**STAFF'S
REQUEST ANALYSIS
AND
RECOMMENDATION**

04PR0331

**13800 Hull Street Associates, LLC
(Bank of Richmond, Phase 2)**

REQUEST: Site Plan Approval.

04PR0331
BANK OF RICHMOND
PHASE 2

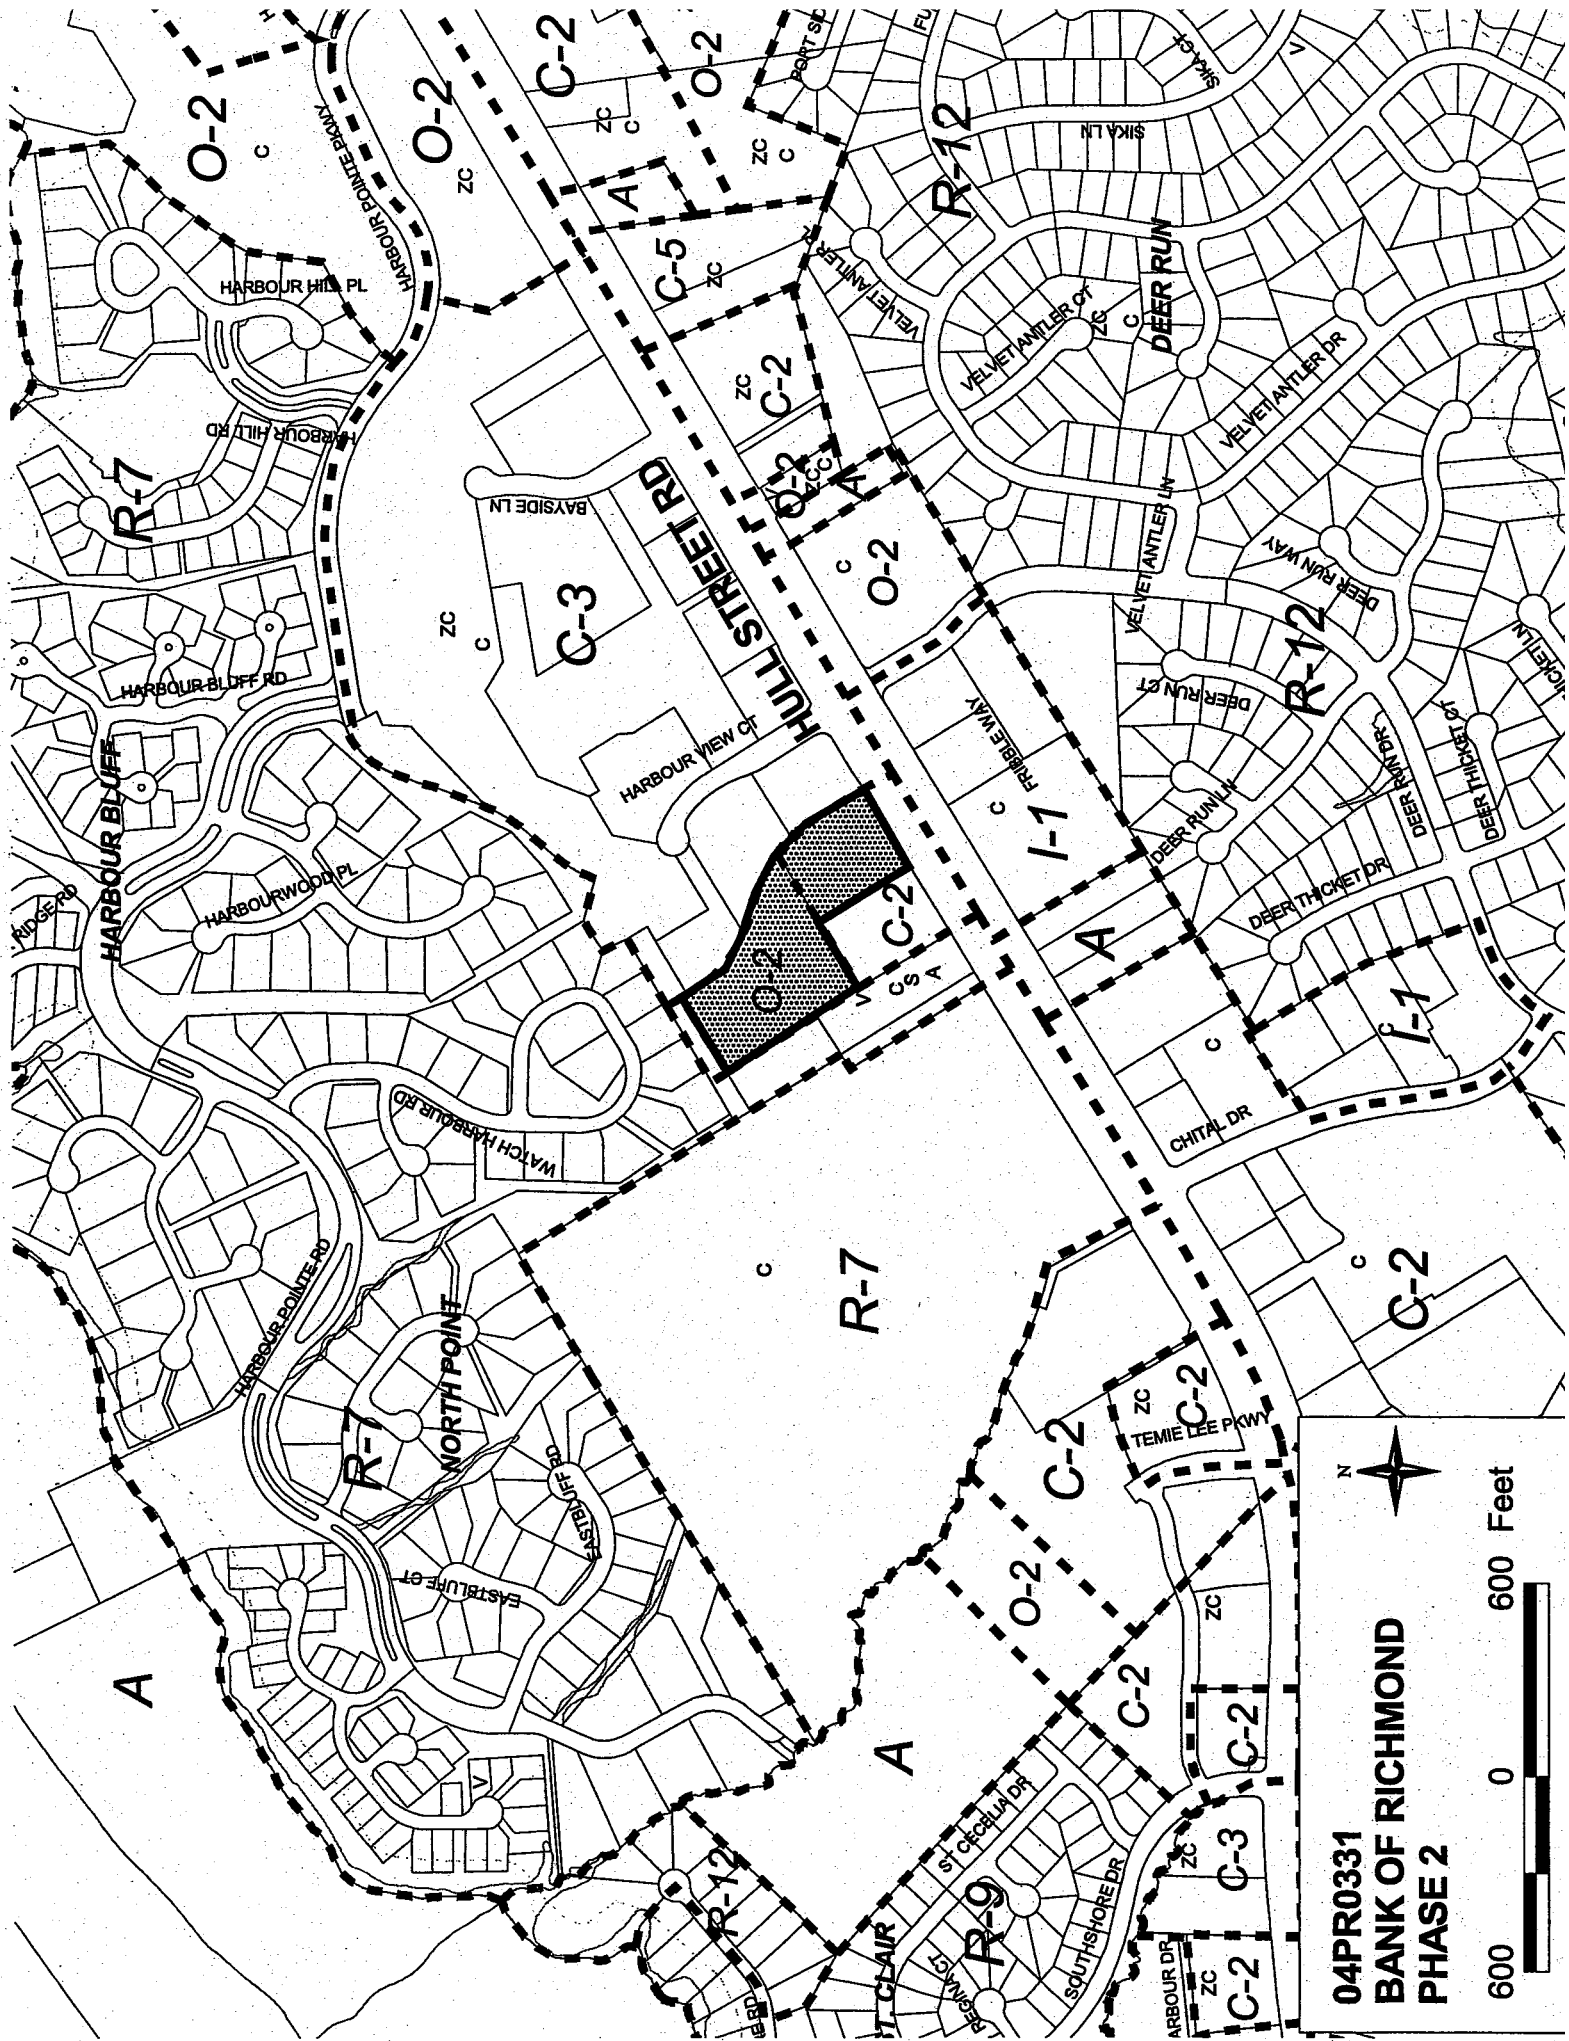
1. Show the County Project Number 04-0143 on the lower right hand corner of each sheet. (U)
2. Show manhole numbers for all the existing manholes. For manhole #4, show the proposed manhole top proposed under County Project Number 02-0356. (U)
3. Show all of the existing sewer line easement on the plan. (U)
4. Show the existing sewer lateral for CVS at manhole #4. (U)

6. The access road on the Phase 2 plans does not match the access road on the Phase 1 plans in the vicinity of the Bank of Richmond/CVS property line. Clarify (this condition). (EE)

7. Delineate the drainage area for Structure 2. (EE)
8. Provide drop inlet calculations for Structure 2 on standard VDOT calculation sheets. (EE)
9. All existing and proposed drainage easements must be shown. Address for Structures 1 and 2. (EE)

10. The construction entrance must be graphically shown on the plans and constructed as wide as the proposed permanent entrance. (EE)
11. A minimum ten (10) foot break must be provided in the low area of the silt fence. The break must be backfilled with stone to within one (1) foot of the top of the silt fence to serve as an overflow. A detail must be shown. (EE)

12. Specify the amount of new impervious area on sheet C2. (EE)
13. The Upper Swift Creek pro rata fee must be paid. This fee will be calculated once the above information has been provided. (EE)
